# CITY OF ALBUQUERQUE

RE: Los Angeles Center (Lowe's out-parcels), Tracts A-1-B-1-B & A-1-B-1-C  
**Grading and Drainage Plan for Grading, Paving and Building Permit**  
SW Corner of Paseo del Norte & San Pedro PE Stamp: 7/11/12 ( **D18-D014D** )

ENGINEER'S SEAL	LOS ANGELES CENTER TRACTS A-1-B-1-B-1-A-1-B-1-C	DRAWN BY WCWJ
		DATE 5-15-12
	GRADING AND DRAINAGE PLAN	21204-LAYOUT-3-28-12
		SHEET #
		JOB #
		21204

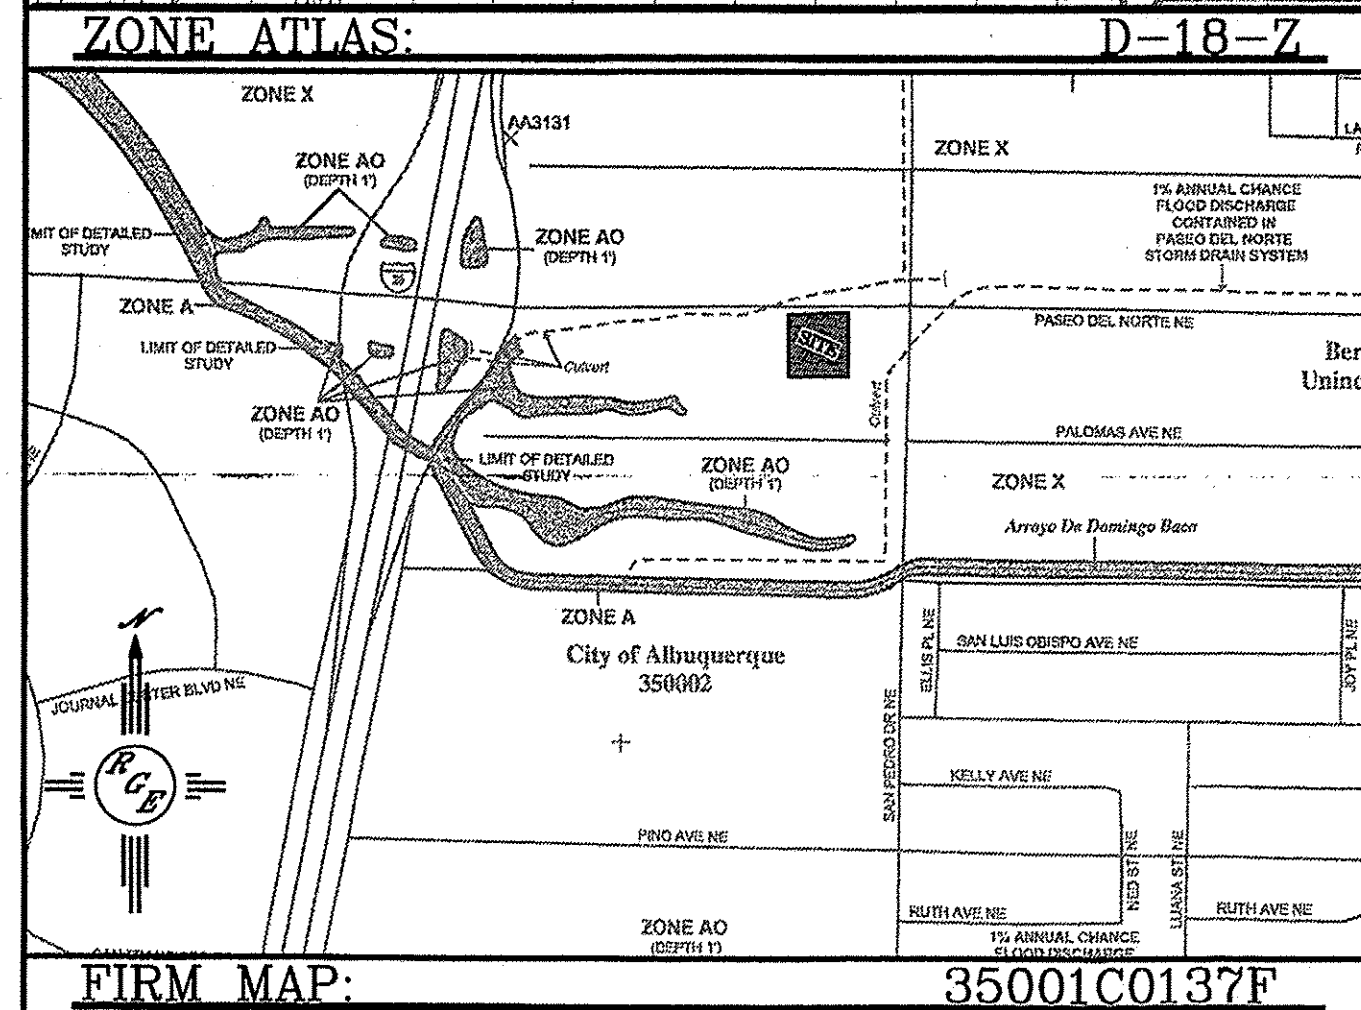
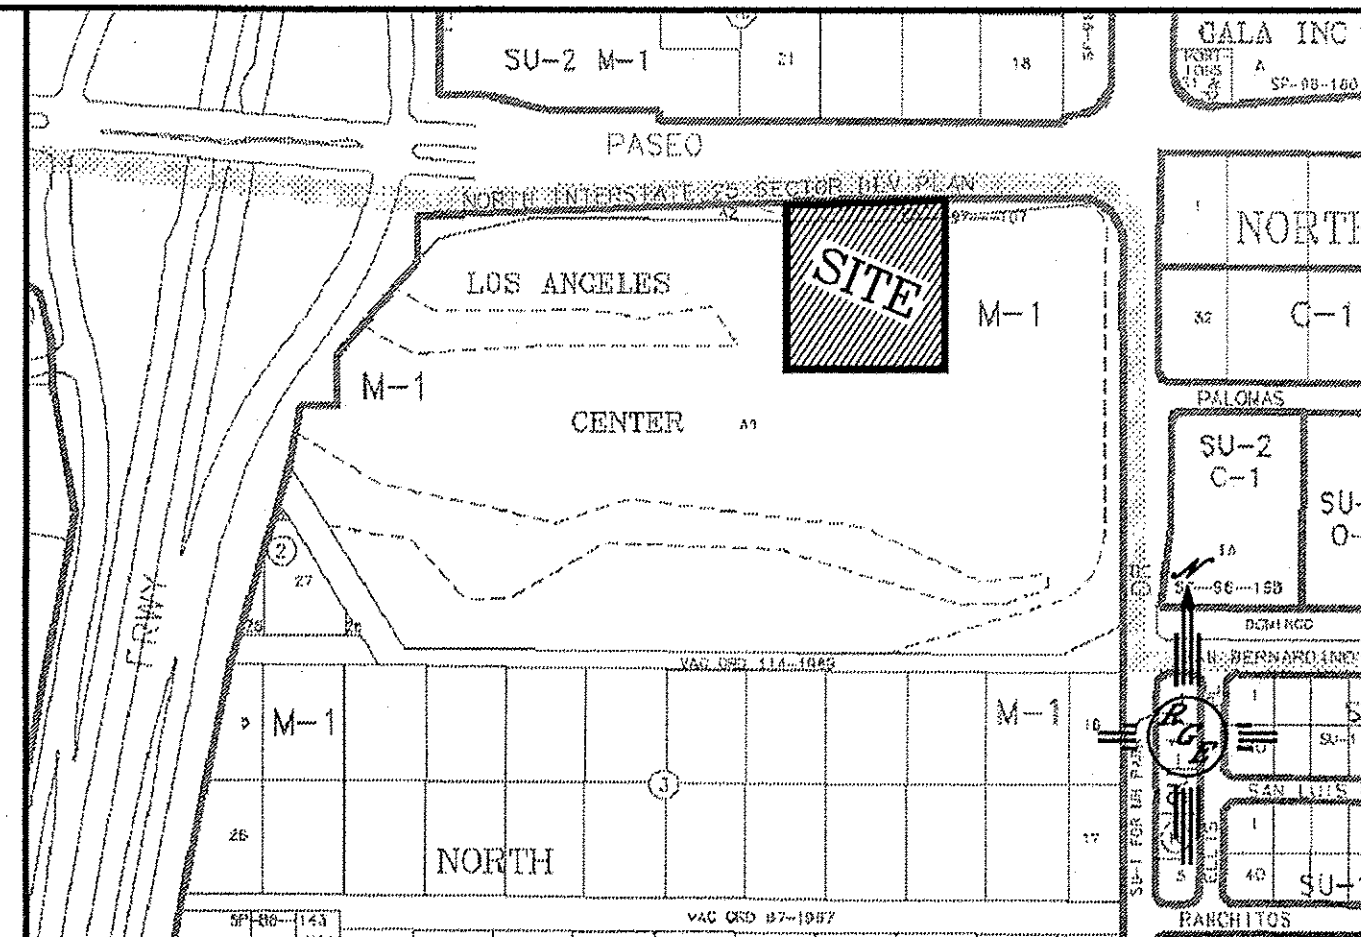
1. Per the DPM Chapter 22 Section 9, runoff from the trash enclosure pad is required to drain to the sanitary sewer.
2. The Building Permit set must include the revised Master Utility Layout, which shows the Dumpster Drain routed through a grease trap, with and approved discharge to the Sanitary Sewer system.
3. Albuquerque's MS4 Permit became effective March 1st, 2012. Grading and Drainage Plans and Drainage Reports must comply with the requirements of the new permit (<http://www.cabq.gov/planning/landcoord/Hydrology.html>).
